Access Compliance Report

Public Rights-of-Way

| Intersection ID: 43646 | Main Street: CEDAR_CROSSINGS_DR | Cross Street: CALLOW_FOREST_DR | Location: SE |
| ADA ID: 6D1C63AD609C | Ramp Type: PerpDiag | Initial Pass/Fail: Fail | Overall Compliance: No |

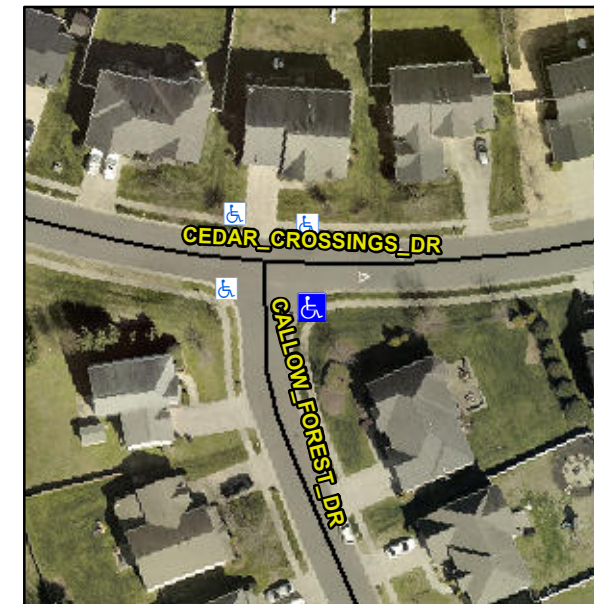
R304.2.2, R304.5.3

| Compliance | Description | Data | Compliance | Description | Data |
|------------|-----------------------|------|------------|-----------------------------|------|
| N/A | Ramp Length (in) | 48.0 | No | Ramp Slope (%) | 9.7 |
| Yes | Ramp Width (in) | 57.0 | No | Ramp XSlope (%) | 3.1 |

Remove & Replace Curb Ramp With Two New Directional Ramps or Equivalent.
